# PLANNING COMMISSION

**SUBJECT:** Land Use Code Simplification and Reformat Project: Administrative and Technical Standards Manuals

Attachment A – Proposed Revisions to the Solid Waste and Recycle Disposal, Collection, and Storage Standards (March 2012 Draft – Section 4 of the Technical Standards Manual)

**SECTION 4.0: SOLID WASTE AND RECYCLE DISPOSAL  
COLLECTION AND STORAGE**

OCTOBER 24, 2011 FIGURE 3A - DOUBLE METAL CONTAINER ENCLOSURE (2 to 8 CUBIC YARDS)  
SCALE: 1" = 5'

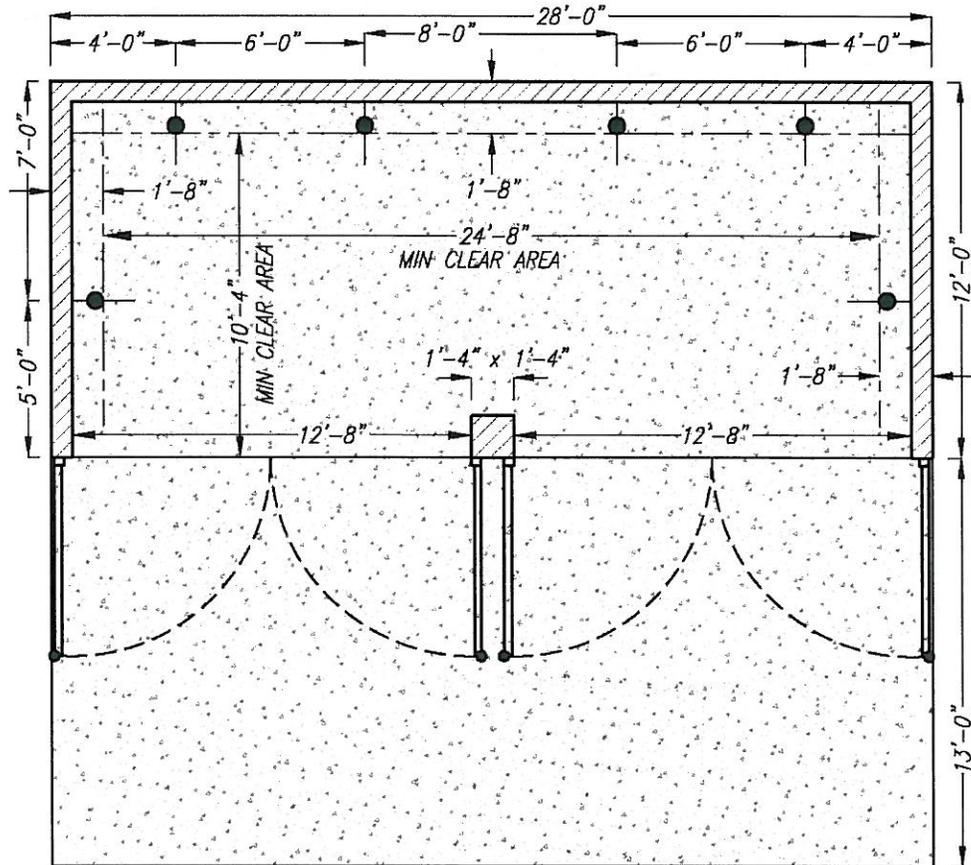
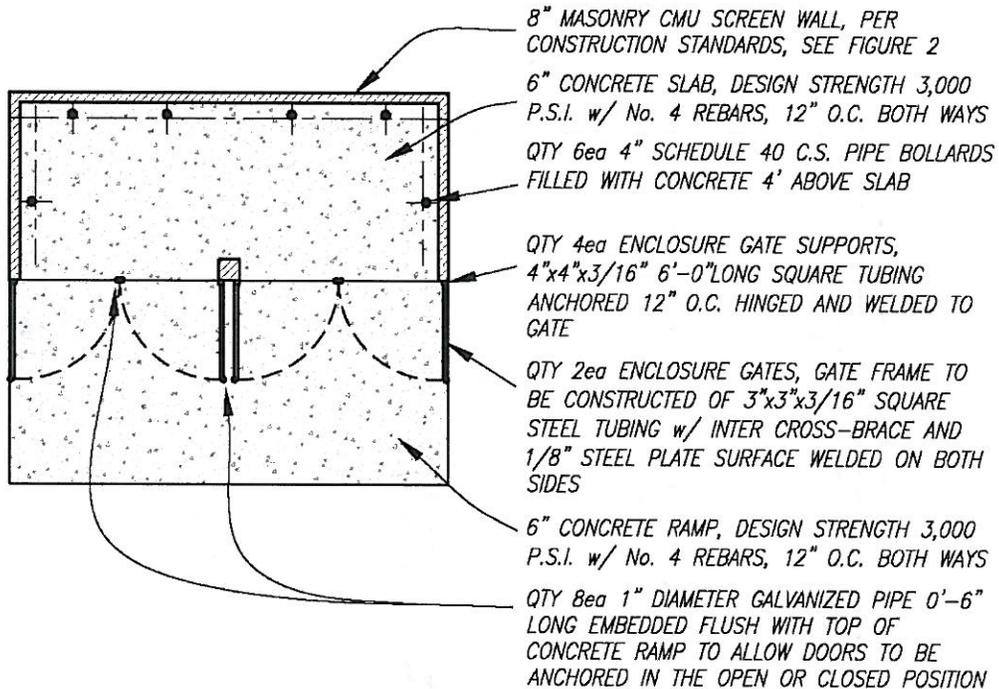
<sup>3</sup> The standard has been revised to reduce the number of required bollards from 8 to 6.

OCTOBER 24, 2011 FIGURE 3B - SINGLE METAL CONTAINER ENCLOSURE (2 to 8 CUBIC YARDS)  
SCALE: 1" = 5'

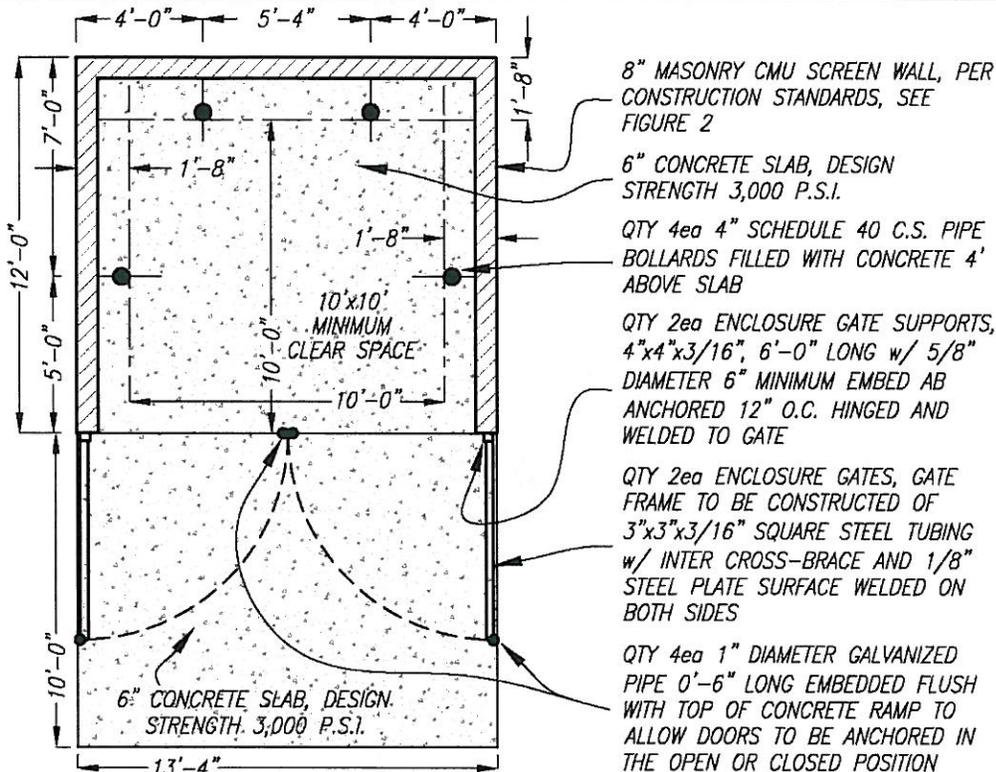
<sup>4</sup> The standard has been revised to reduce the number of required bollards from 6 to 4.

OCTOBER 24, 2011 FIGURE 3A - DOUBLE METAL CONTAINER ENCLOSURE (2 to 8 CUBIC YARDS)  
SCALE: 1" = 5'

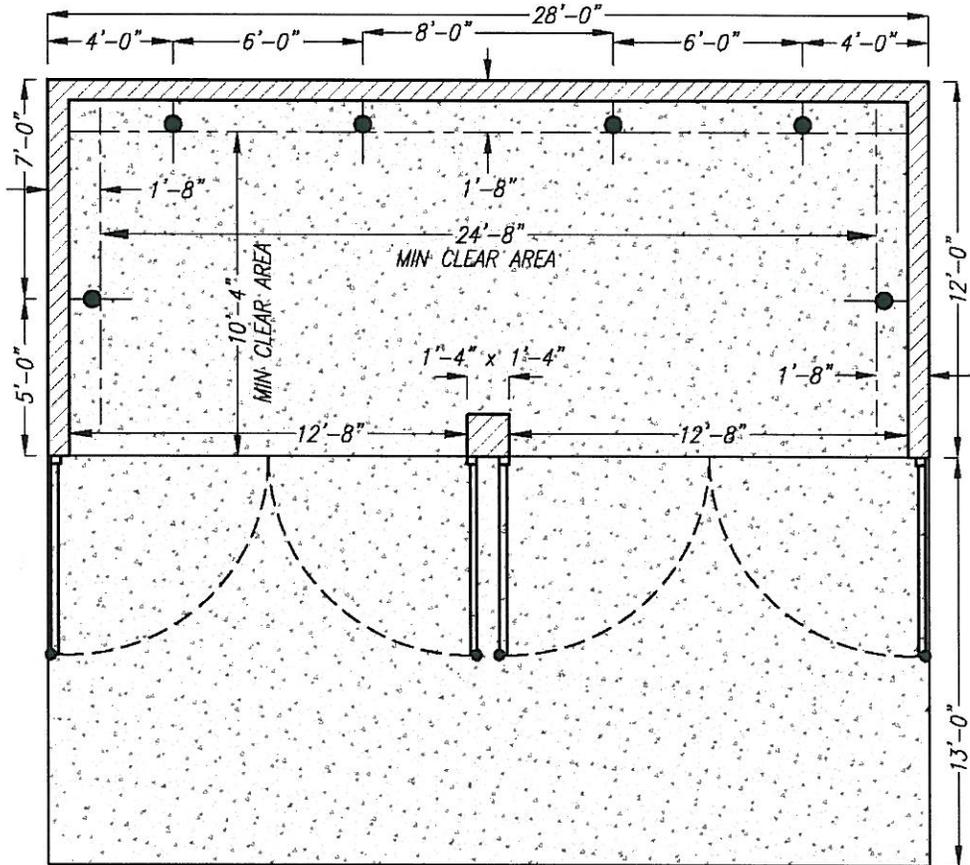
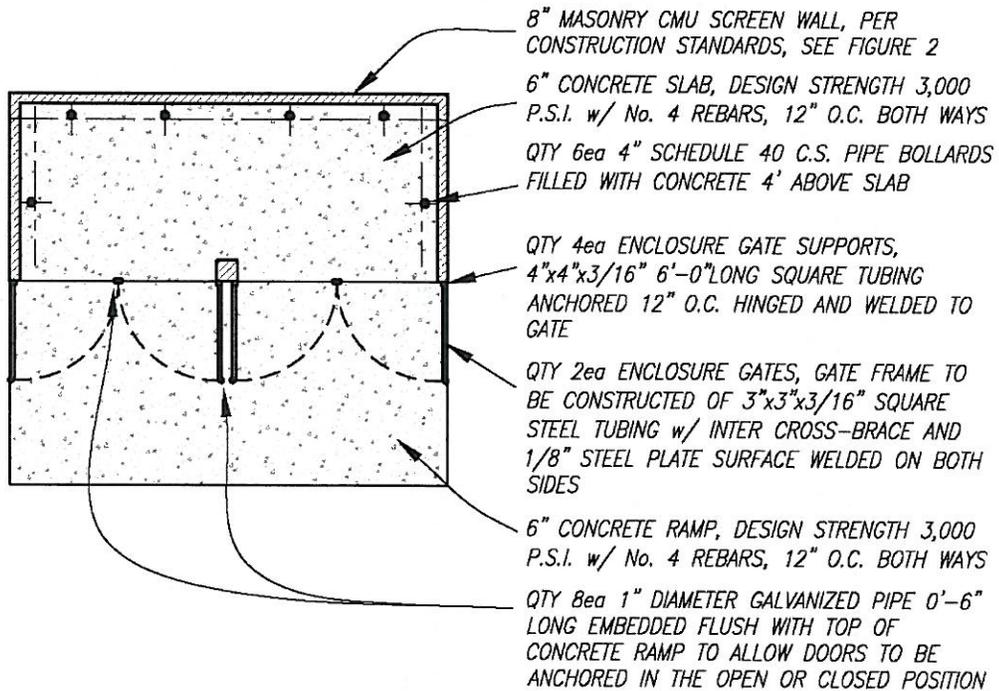
<sup>3</sup> The standard has been revised to reduce the number of required bollards from 8 to 6.

OCTOBER 24, 2011    FIGURE 3B – SINGLE METAL CONTAINER ENCLOSURE (2 to 8 CUBIC YARDS)  
SCALE: 1" = 5'

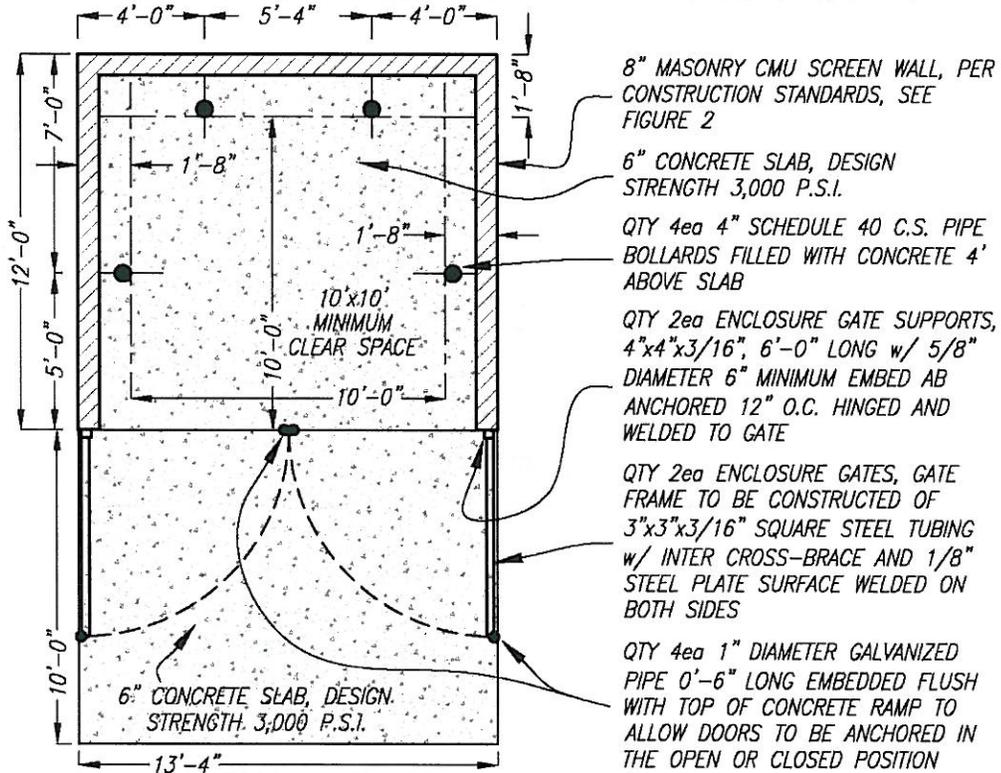
<sup>4</sup> The standard has been revised to reduce the number of required bollards from 6 to 4.
